**PITCH DEVELOPMENT
RADCLIFFE MOOR ROAD, BURY**

HYDROLOGICAL ASSESSMENT

Document Reference: HYD633 Hydrological Assessment
Revision: 2.0
Date of Issue: 28th July 2022
Report Status: FINAL

**PITCH DEVELOPMENT, RADCLIFFE MOOR ROAD, LITTLE LEVER (APP. REF. 67658)
RESPONSE TO COMMENTS ON THE HYDROLOGICAL ASSESSMENT BY BURY COUNCIL PARKS AND
COUNTRYSIDE DRAFT 1 (UNDATED – RECEIVED 14.06.2022)**

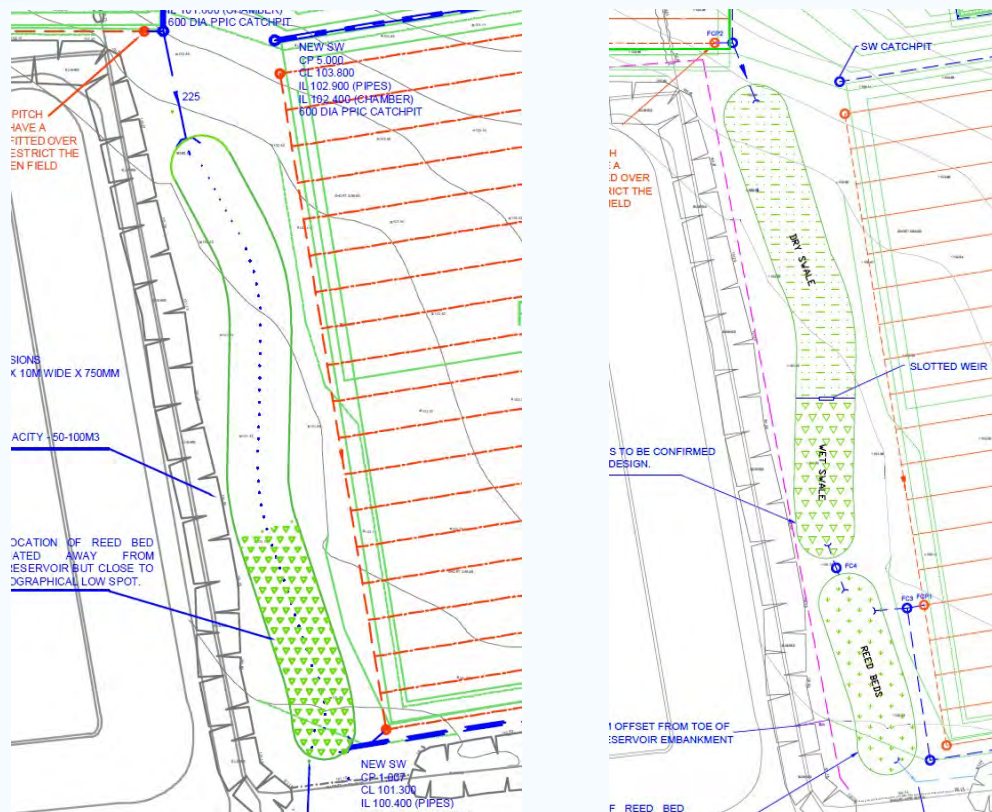
The design of the combined reed bed/swail is flawed.

4.3 In fact there are three distinctly different parts as the swale is a 'dry swale' in the upper portion, then becomes a 'wet swale' and then this swale discharges into the reedbed. The detail of the interface between the dry swale, wet swale and reedbed are a matter of detailed design but I would envisage a slotted weir between the dry and wet swale to make landscape maintenance easier and then a spill weir from the wet swale to maintain a permanent water level in the base with a piped connection into the reedbed.

4.2 The report explains that the swale and reedbed are in two parts. This is shown in the extract below from the Hydrological Assessment drainage strategy plan – both the previous version on the left and the updated plan on the right which shows more detail.

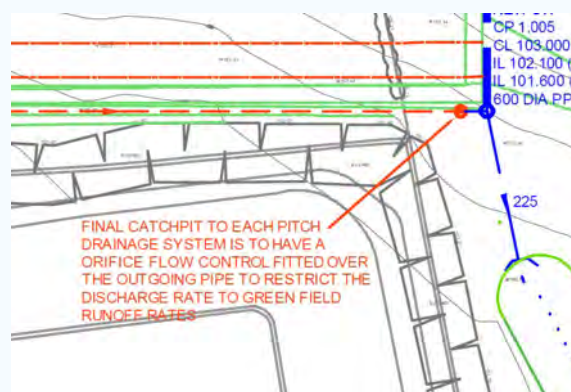
The flow control system will not work as drawn in Figure 9. Constraining the flow at the point indicated without the water having elsewhere to go will cause the manhole to discharge due to the head of water from Pitch 3 and Pitch 4 which are both higher than Pitch 2.

6.1 What is being described in the comment is not what is being proposed. What is being proposed is an orifice flow control to 'each pitch' on the final catchpit. This creates a cascading effect specifically so that one pitch does not hydraulically impact on the subsequent lower pitches. The note encircled specifically states this – see the note below which I have increased in size for clarity.

6.2 See comment 6.1, there is a proposed flow constriction on 'each pitch' in the final catchpit from each pitch drainage system. To minimise the risk of contaminates or environmental incidents an amendment has been made to the drainage with the introduction of an additional dry swale length and also the routing of the system means this flow will also pass through the reedbed system fully rather than appear to bypass which it appeared to on the previous drainage strategy drawing.
